ERRATA

AGMA 923-C22

June 2024

The following editorial corrections will be added to the next edition of AGMA 923-C22, *Metallurgical Specifications for Steel and Cast Iron Gearing* (published September 2022).

Figure 16 – Case depth measurement locations

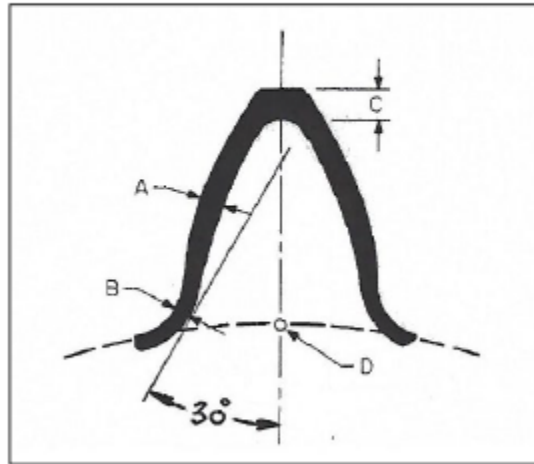
Error: On page 17 of AGMA 923-C22, in the effective case depth procedure, there is an erroneously numbered reference [6], which is not included in the bibliography, see highlighted below.

effective case depth: Per SAE J423 microhardness test method. For carburized and hardened gearing, Figure 16 indicates where to measure case depth and core hardness. It is based on reference [6] for carburized gearing. The 30° line defines the approximate location for effective case depth measurement at the root fillet.

Correction: Figure 16 references an AGMA Fall Technical Meeting paper from 2019. The correct bibliography listing is:

19FTM25, *Optimum Carburized and Hardened Case Depth*

A correct citation number and the bibliography listing for 19FTM25 will be included in the next revision of AGMA 923.
